Beaver Valley Power Station
Unit Nos. 1 and 2

License Amendment Requests
302 and 173

Extended Power Uprate

Subject: Beaver Valley Power Station, Unit No. 1 and No. 2
BV-1 Docket No. 50-334, License No. DPR-66
BV-2 Docket No. 50-412, License No. NPF-73
License Amendment Request Nos. 302 and 173

FIGURE 3.4-1
DOSE EQUIVALENT I-131 Primary Coolant Specific Activity Limit
Versus Percent of RATED THERMAL POWER with the Primary
Coolant Specific Activity > ~~0.10~~0.35 µCi/gram DOSE EQUIVALENT I-131

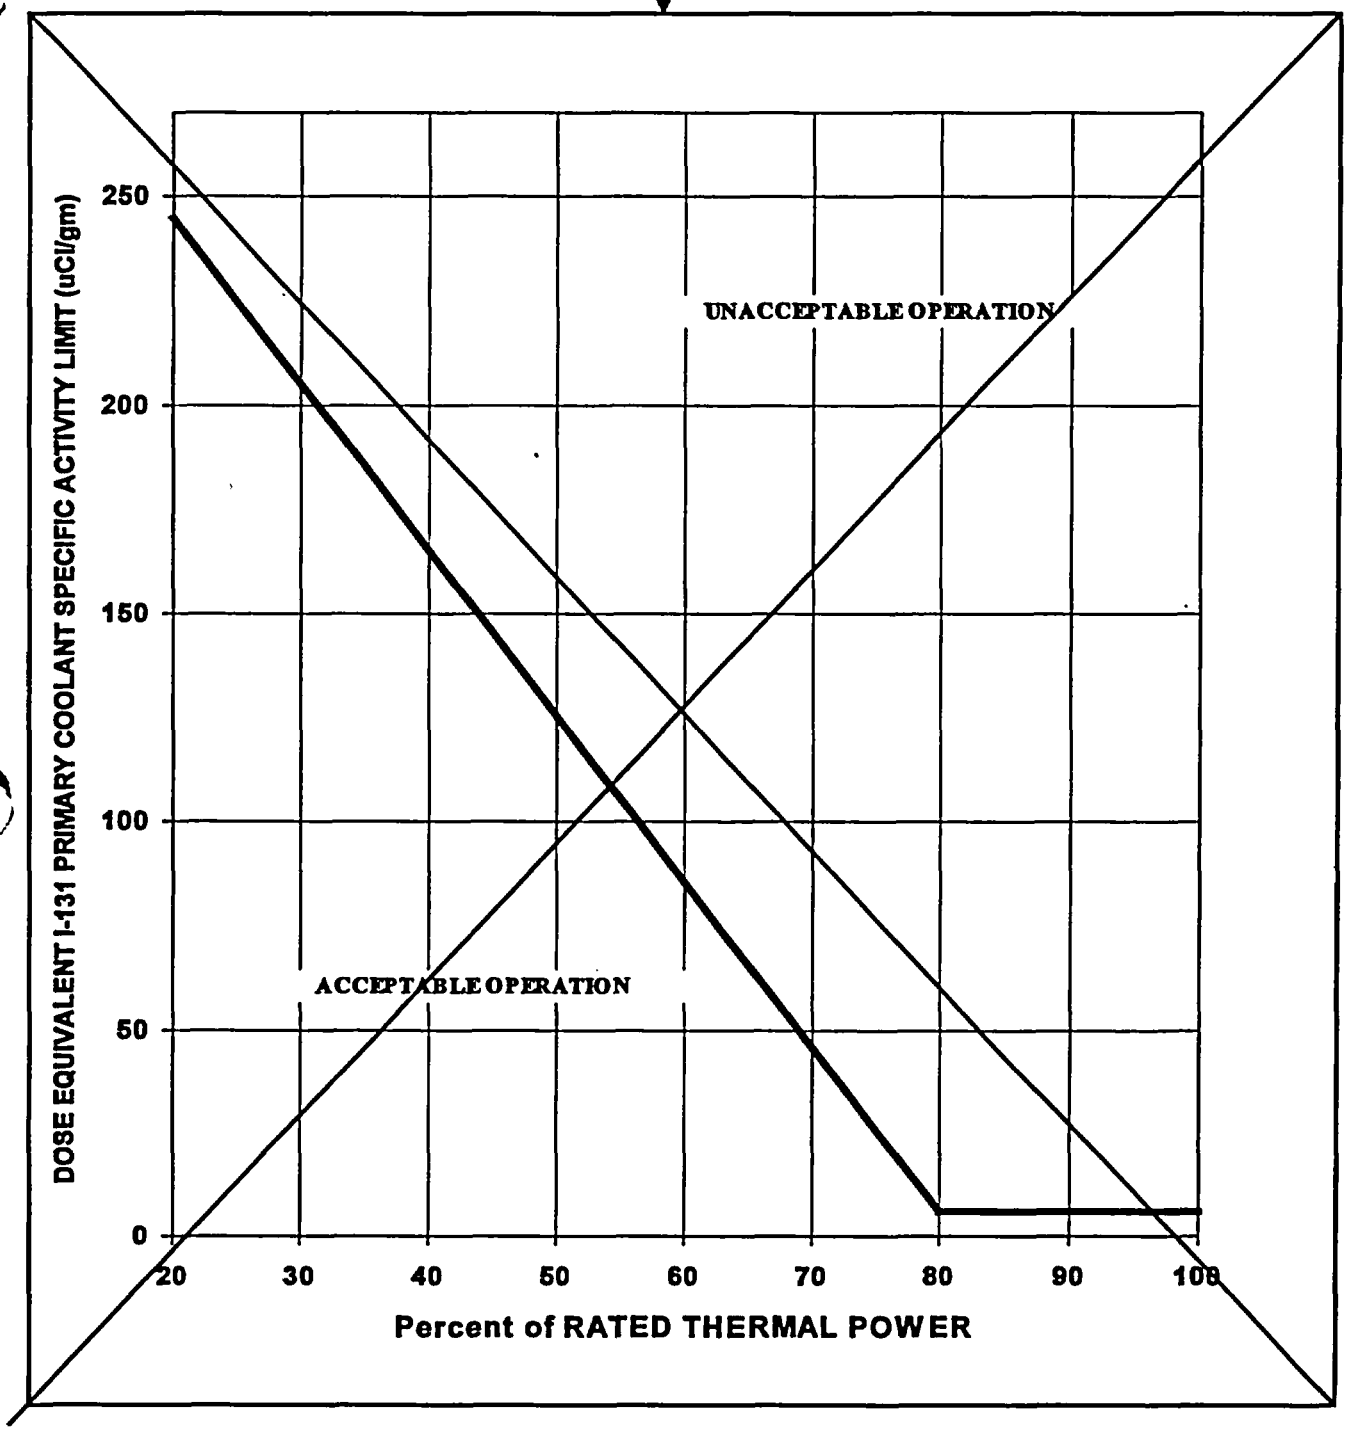
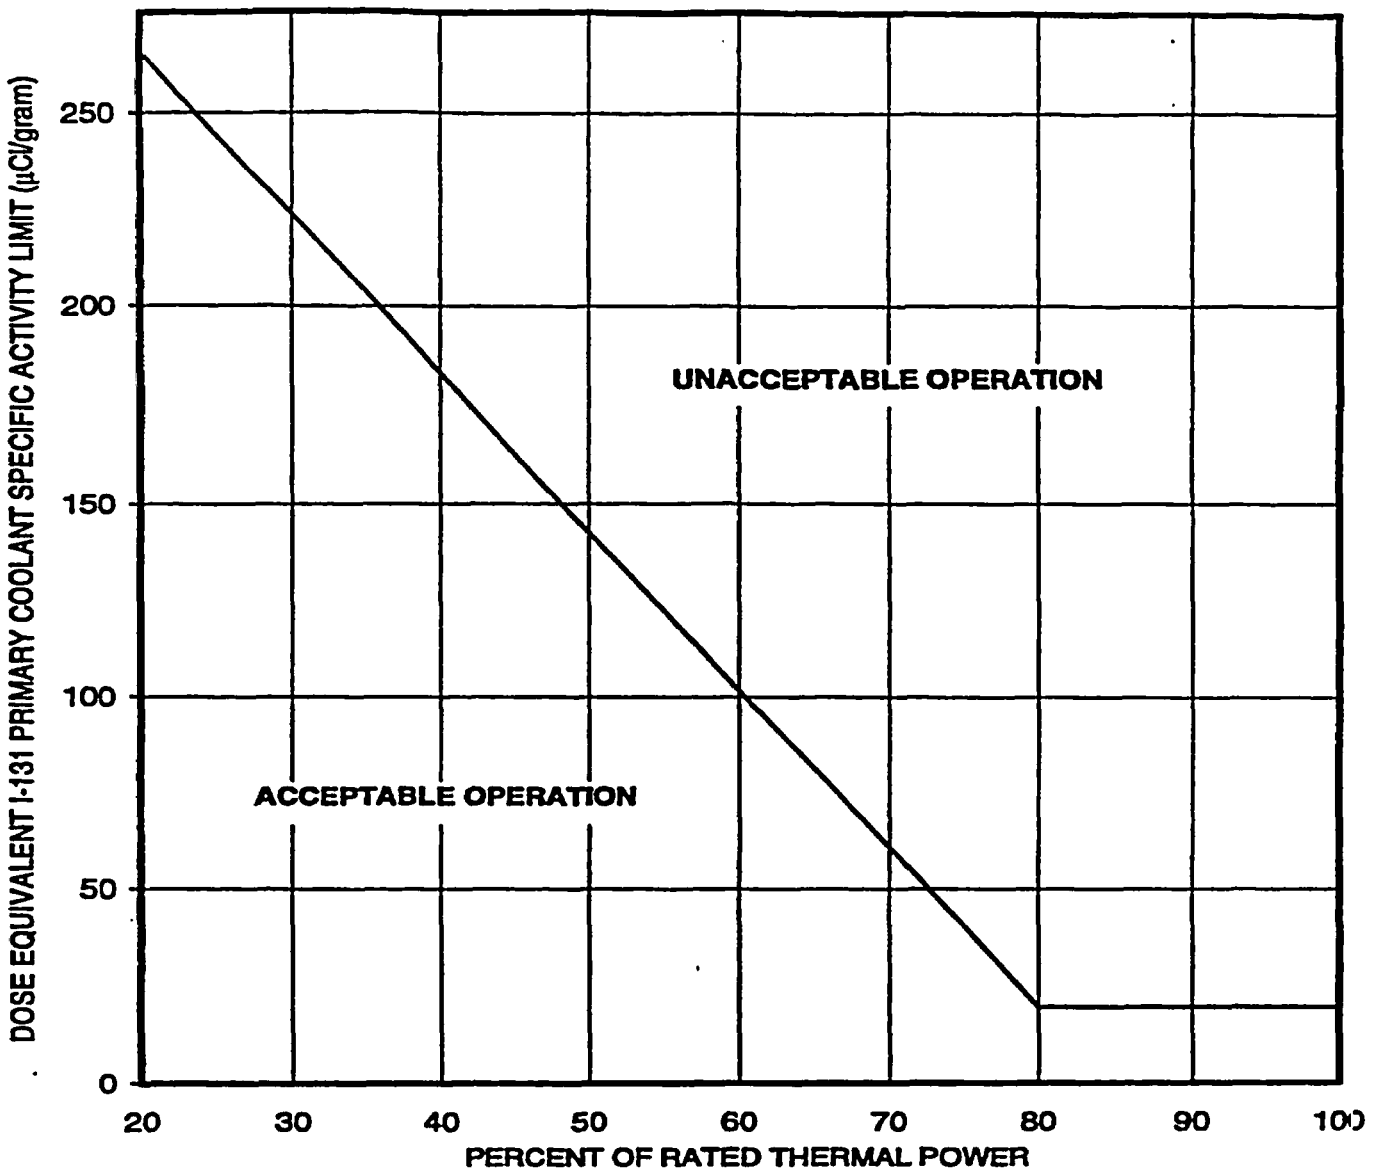
a. With the specific activity of the primary coolant > ~~0.10~~0.35 μCi/gram DOSE EQUIVALENT I-131[1] for more than 48 hours during one continuous time interval or exceeding the limit line shown on Figure 3.4-1, be in HOT STANDBY with T_{avg} < 500°F within 6 hours.

Replace with Insert A1-1.

Insert A1-1.

FIGURE 4.1-4
MAXIMUM (F_QT*PREL) VS AXIAL CORE HEIGHT
DURING NORMAL OPERATION

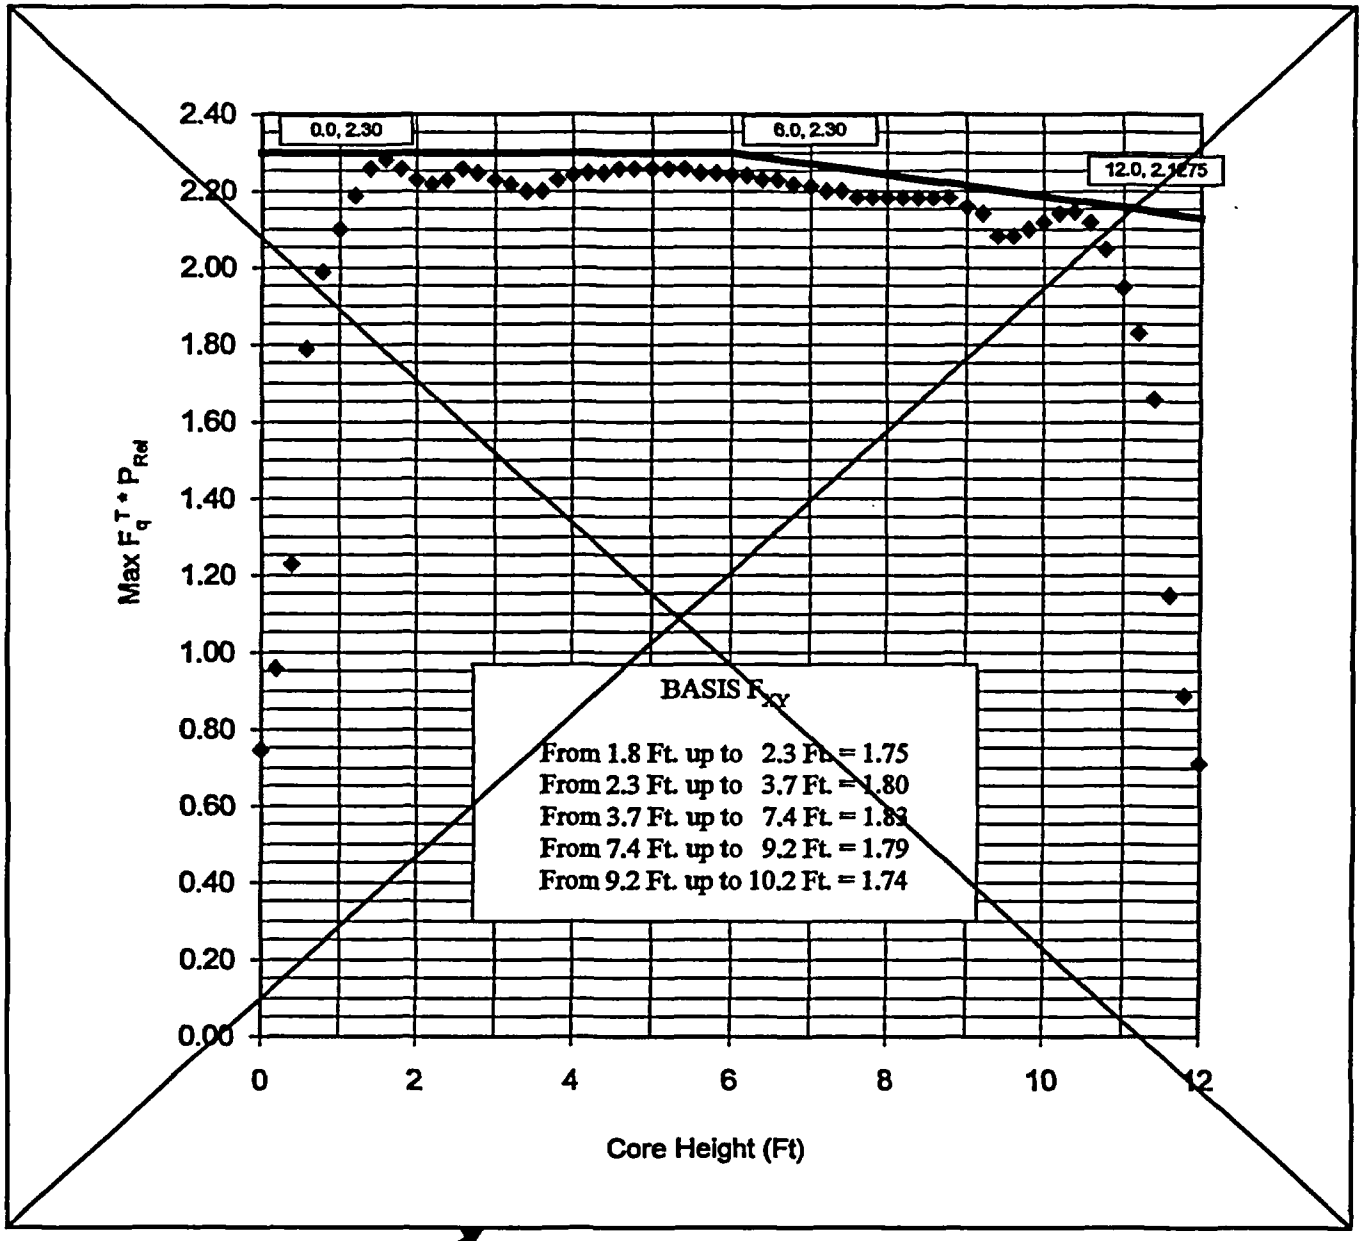
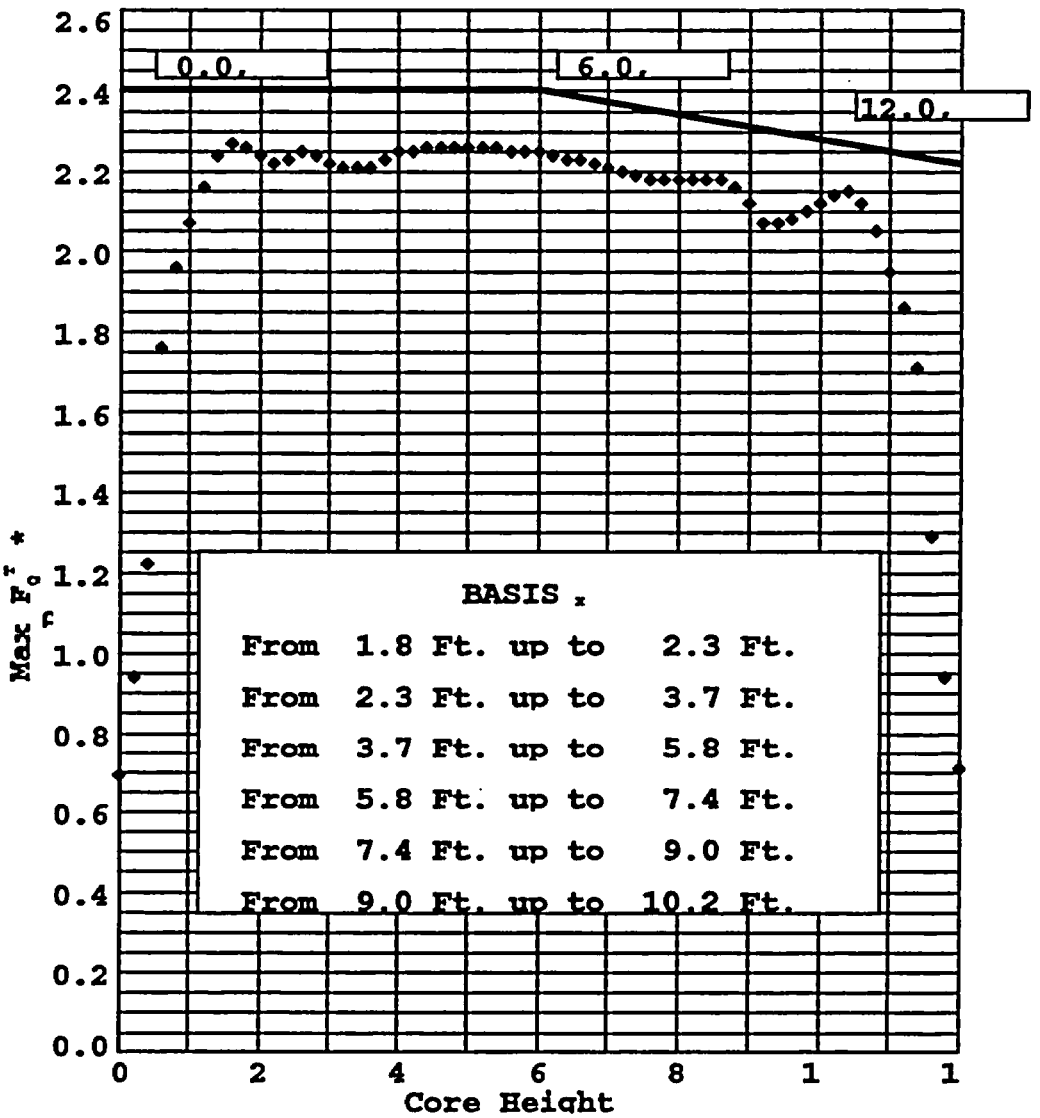
Replace with Insert C1-2.

Insert C1-2.

Figure 4.1-5
REACTOR CORE SAFETY LIMIT
THREE LOOP OPERATION
(Technical Specification Safety Limit 2.1.1)

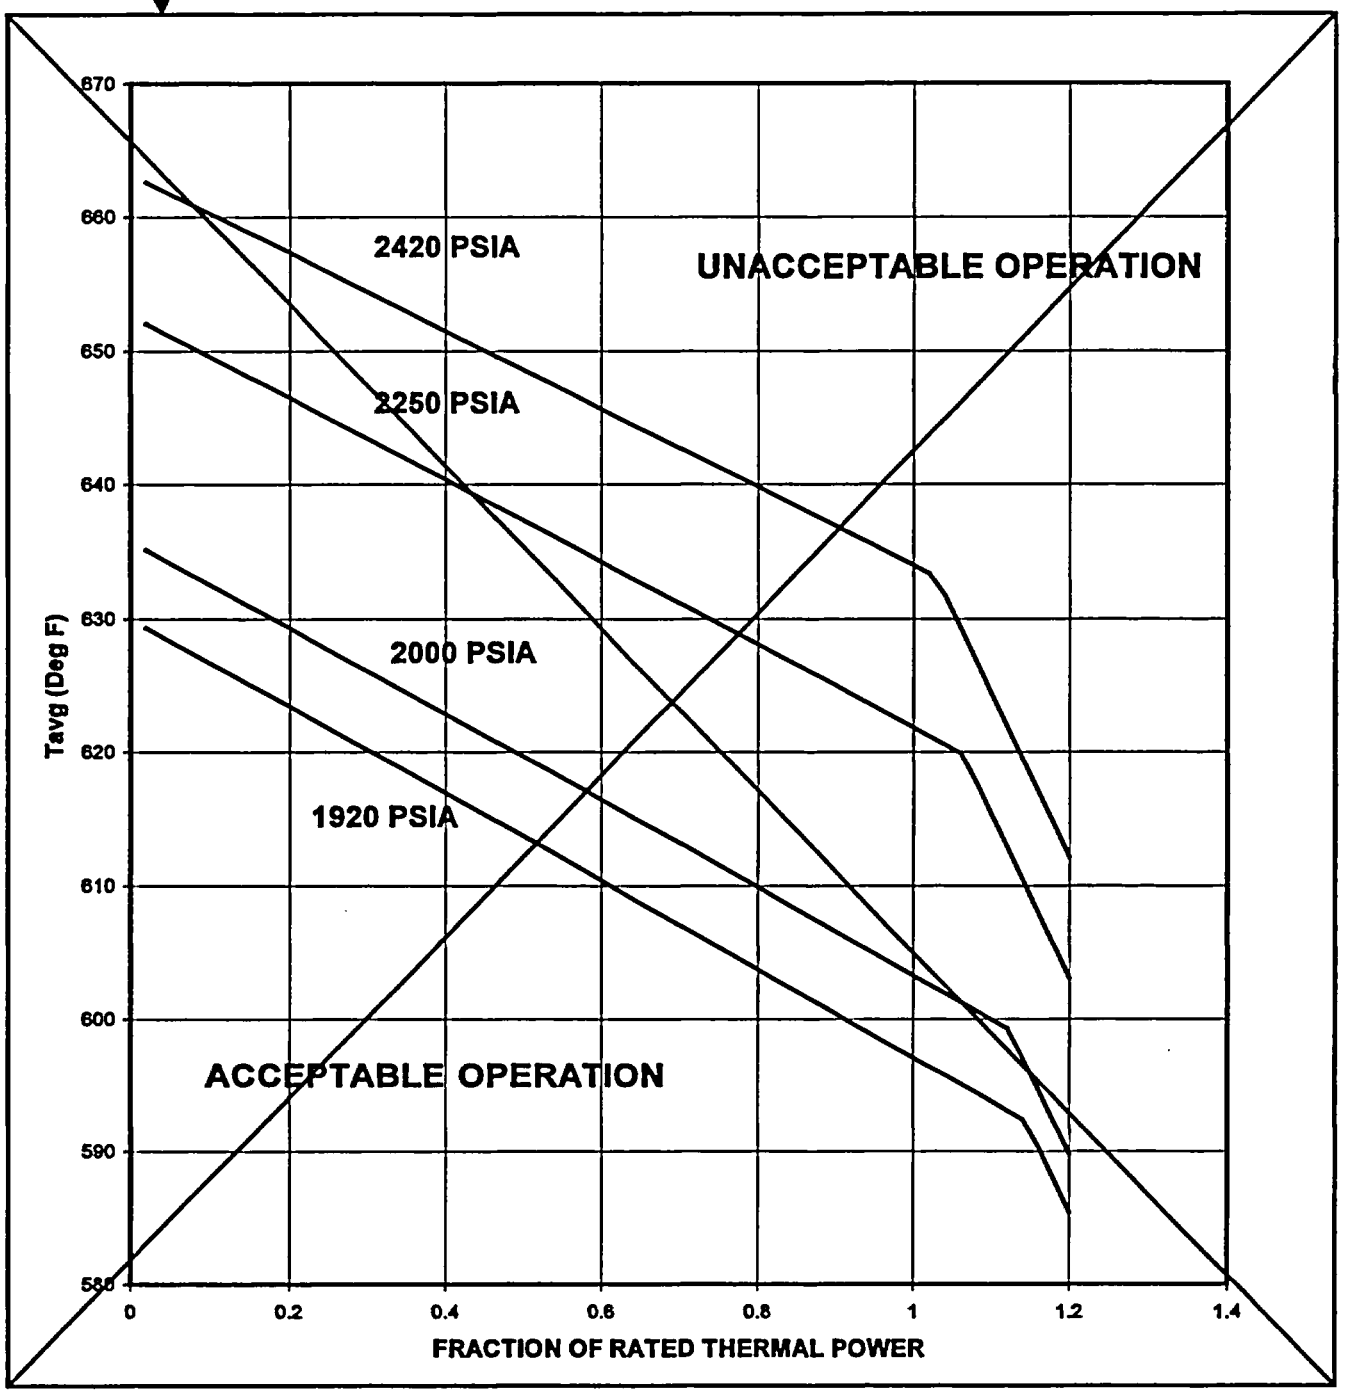
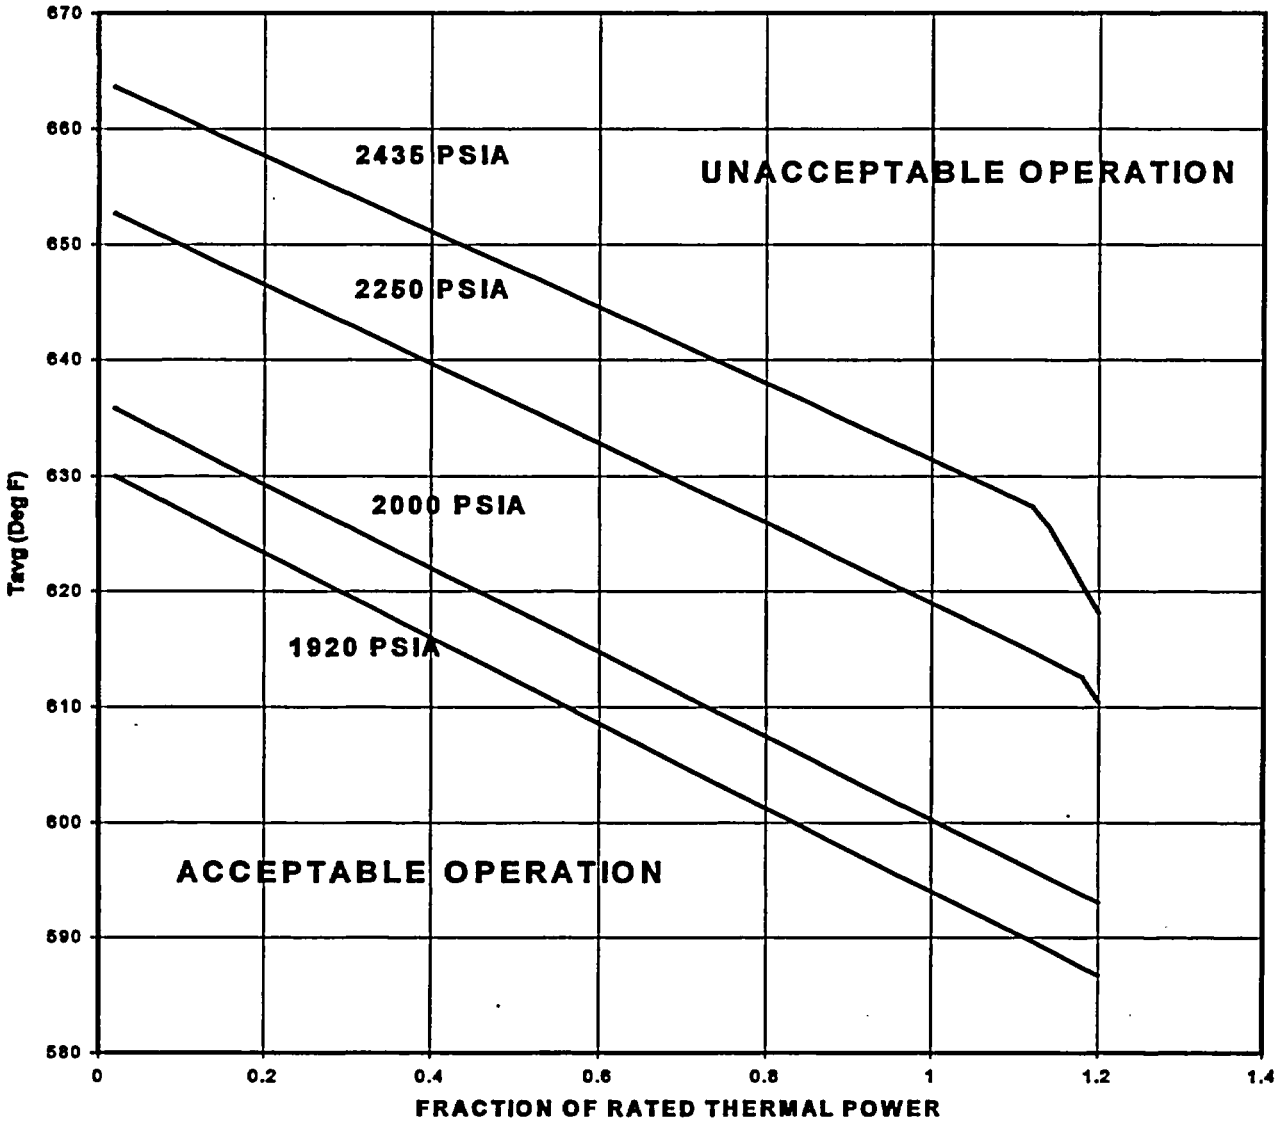
Replace with Insert C1-3.

Insert C1-3.

Figure 4.2-1
Reactor Coolant System Heatup
Limitations Applicable for the First ~~22~~ 21 EFPY (TS 3.4.9.1)

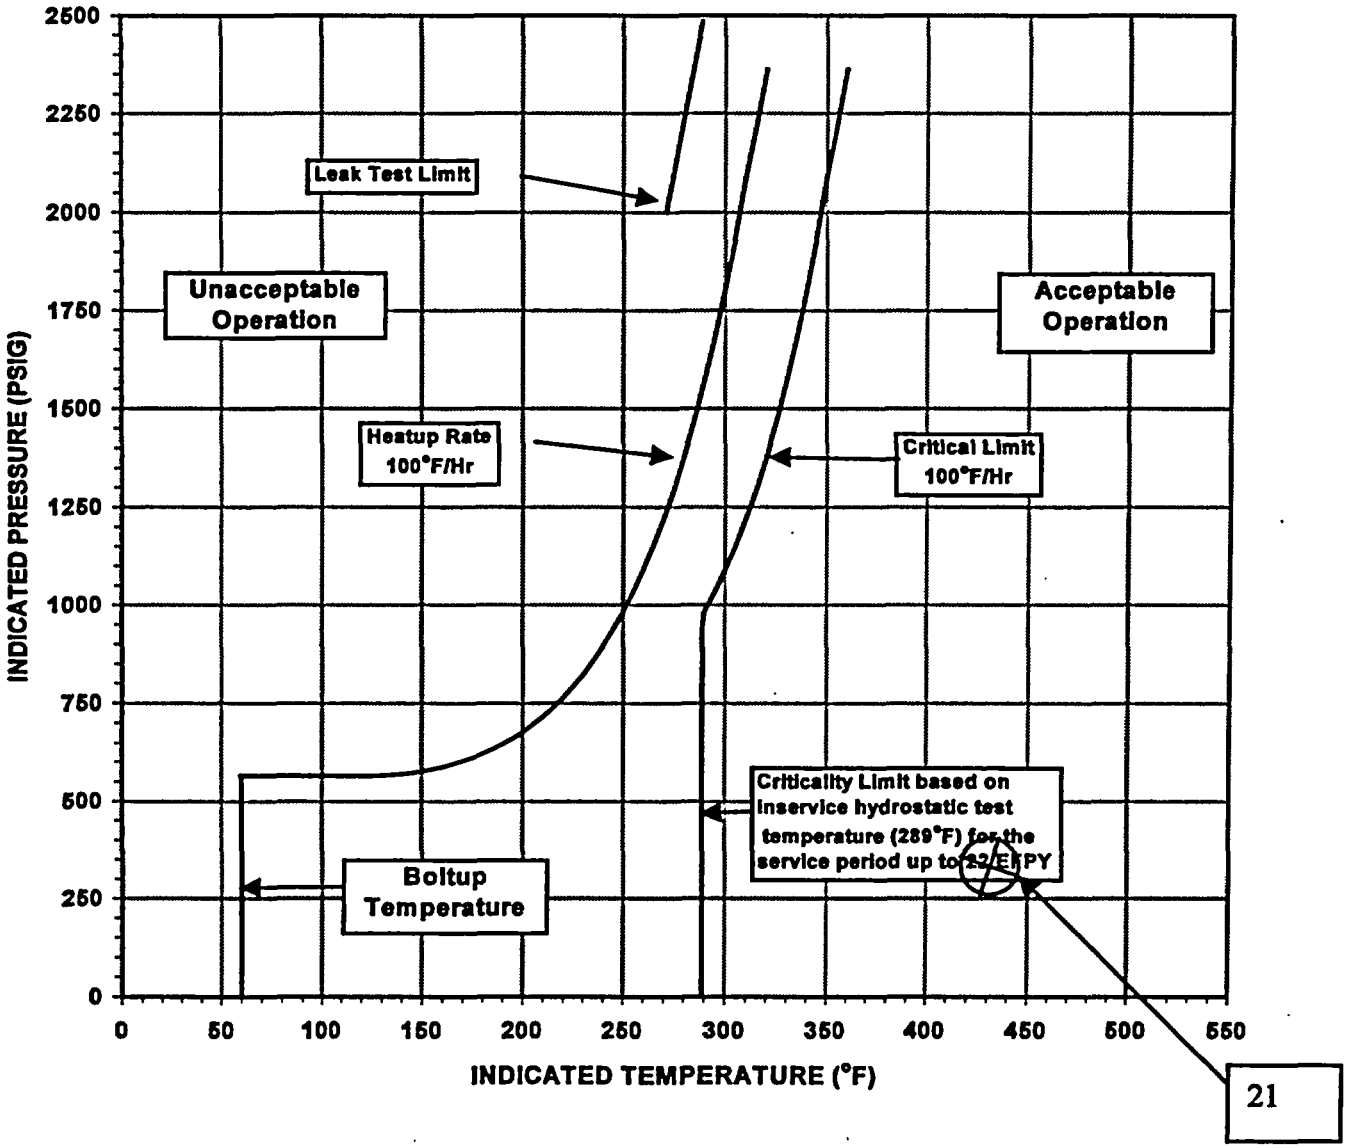
LIMITING ART VALUES AT ~~22~~ 21 EFPY: 1/4T, 233°F
3/4T, 196°F
